EPA/ROD/R01-88/033
September 1988

Superfund Record of Decision:

Old Springfield Landfill, VT

4. Title and Subtitle
SUPERFUND RECORD OF DECISION
Old Springfield Landfill, VT
First Remedial Action

Old Springfield Landfill Site
Area of Proposed Cap

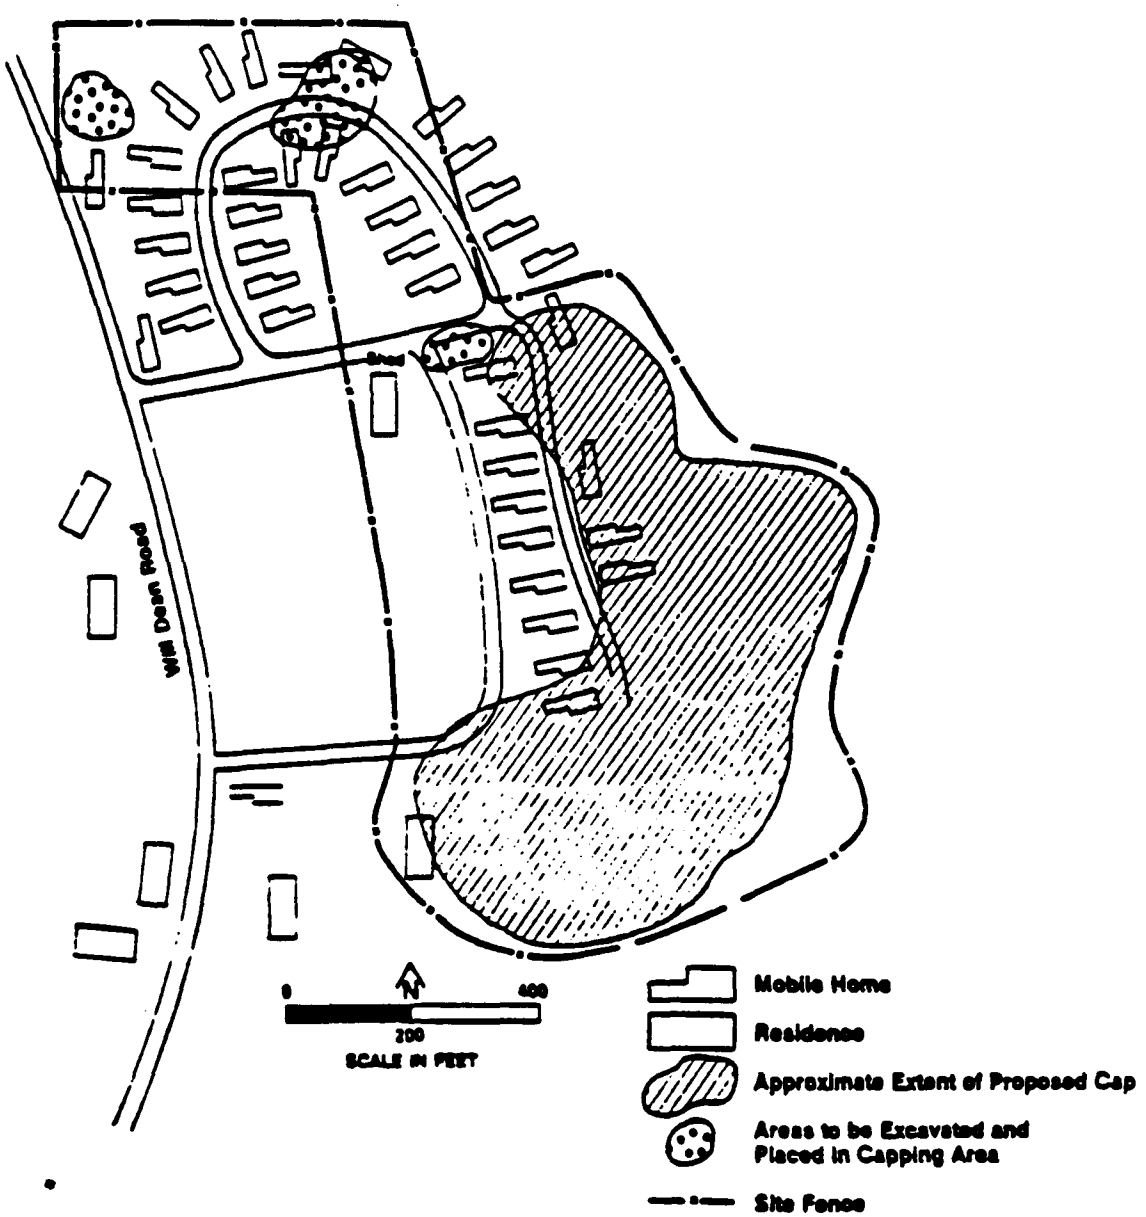
(See Exhibit 1). Residents also requested that warning signs be posted along the fence at access points only.

EPA Response:
See response to citizen comment A.1.a. above.

Box Model

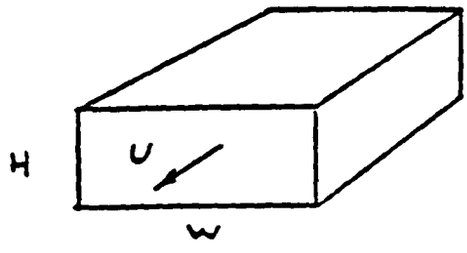
The EPA used a "box model" to define airborne dispersion. The "size" of the box is the cross-sectional area, and the air flow is this area times the average wind speed.
